Transfer 75421 (Gardiner)

T75421 Gardiner
Corrected

T 75421 Limits

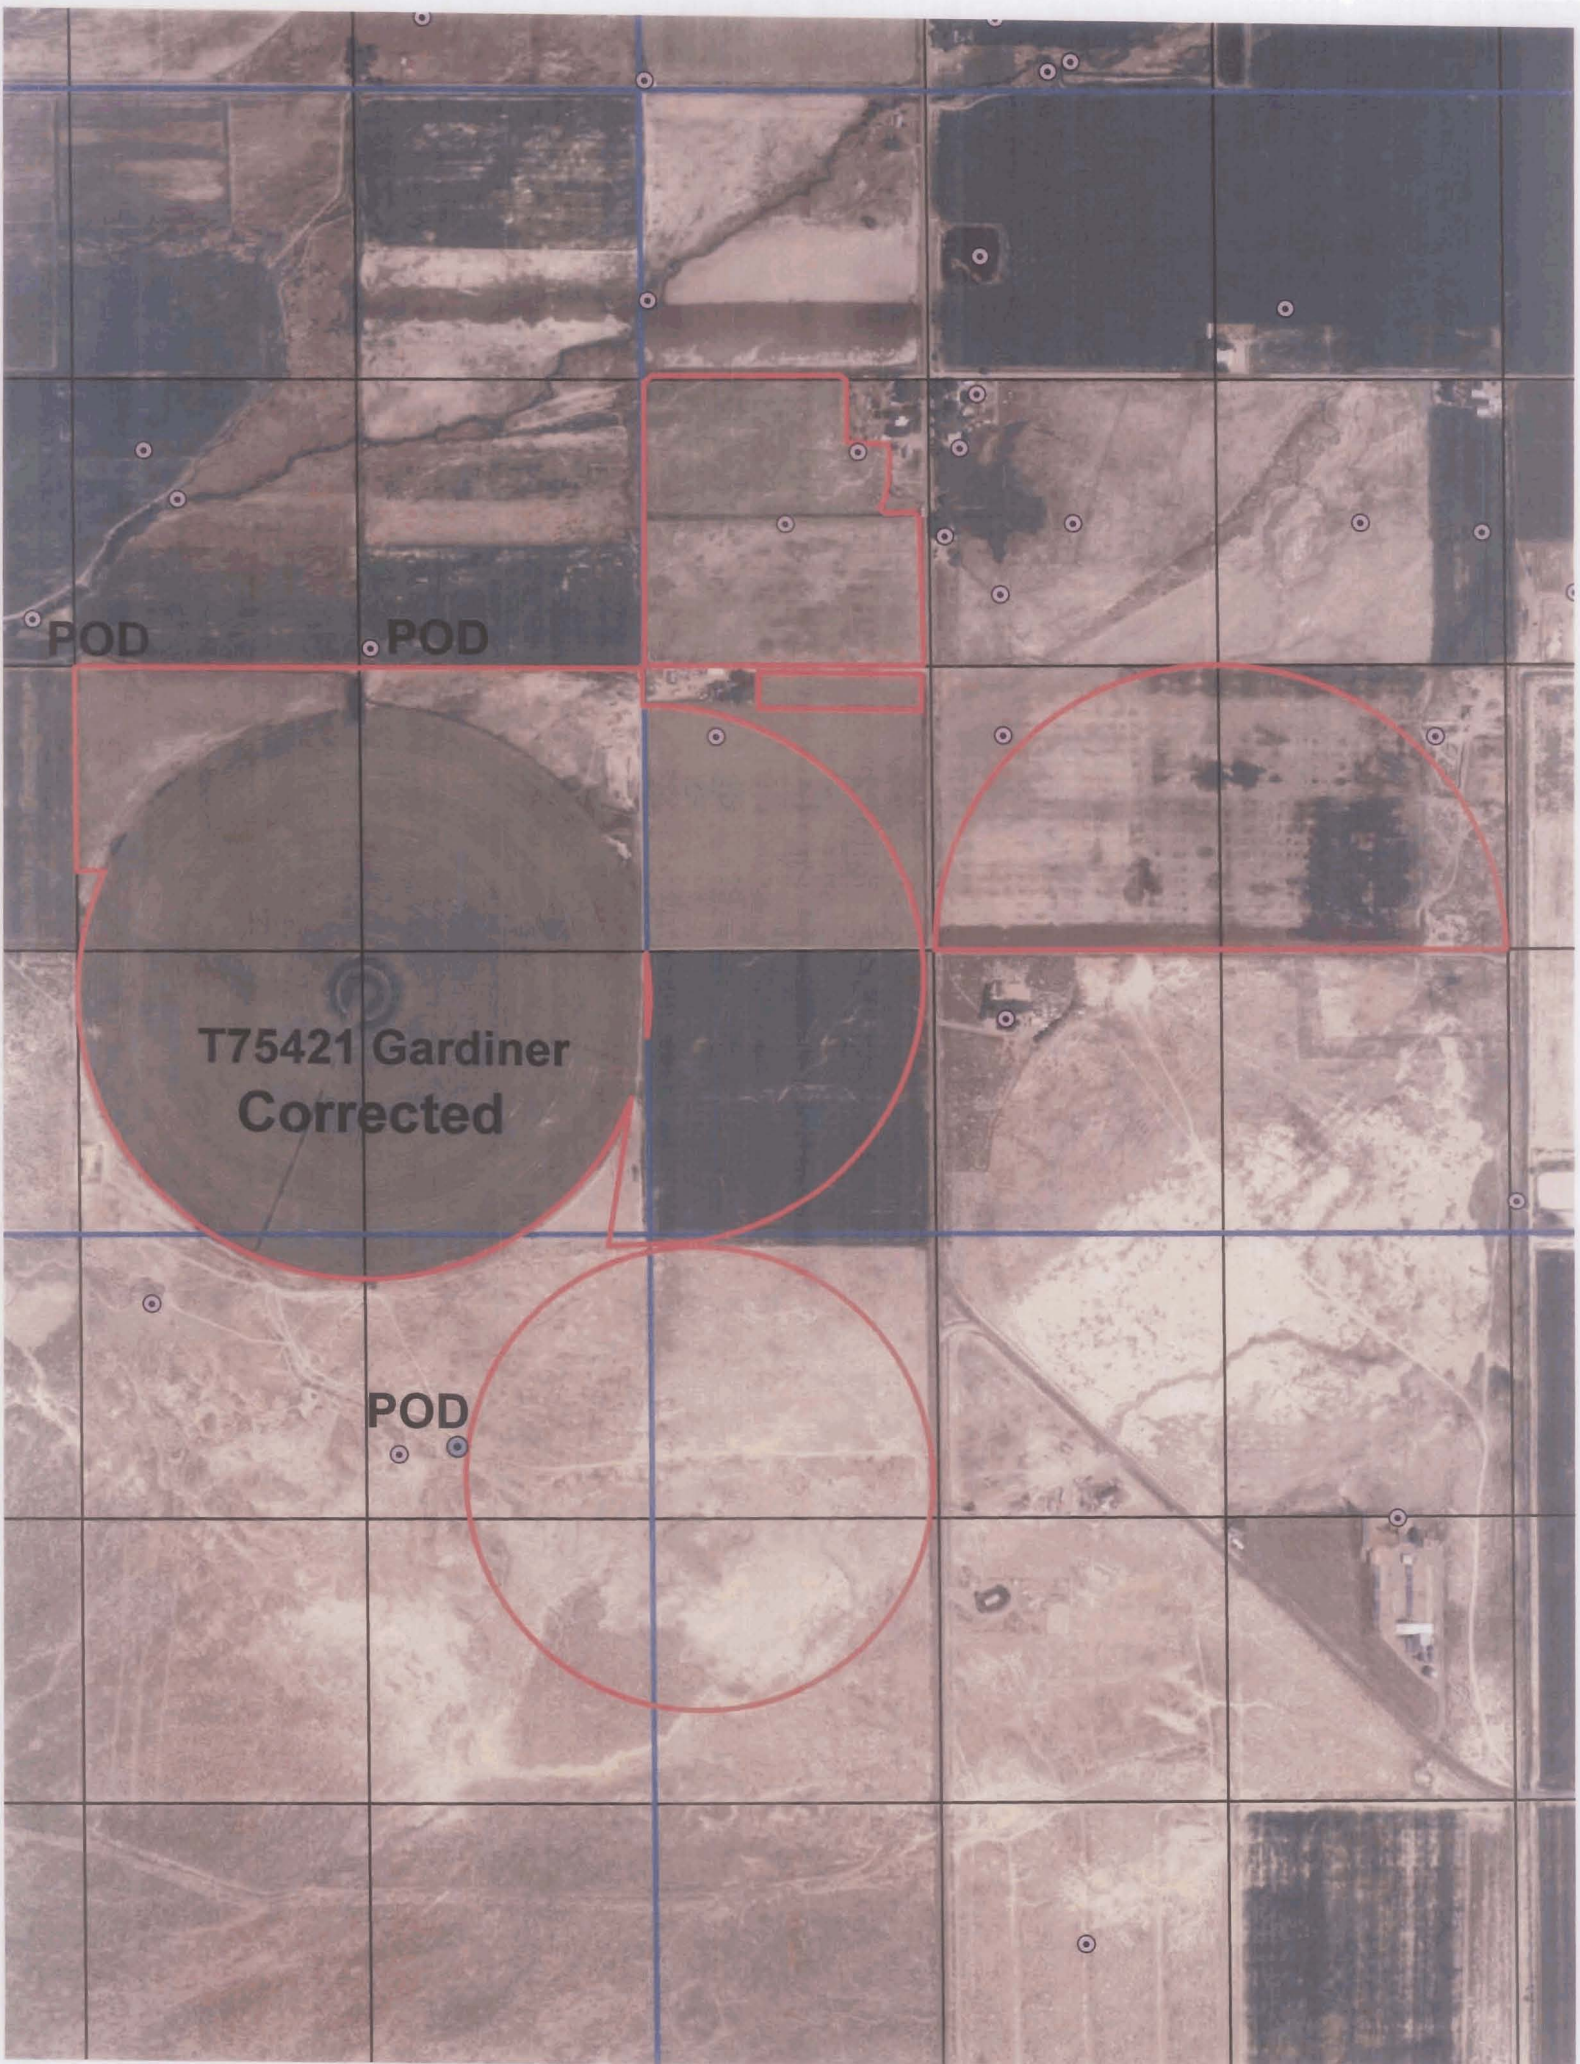
unique acres of 43-4240, 43-2573 & 43-10123 add up to 240 acres. The combined acre limit should NOT be 330 acres
unique acres of 43-301, 43-4232 & 43-10123 add up to 100 acres. The combined acre limit should NOT be 103 acres
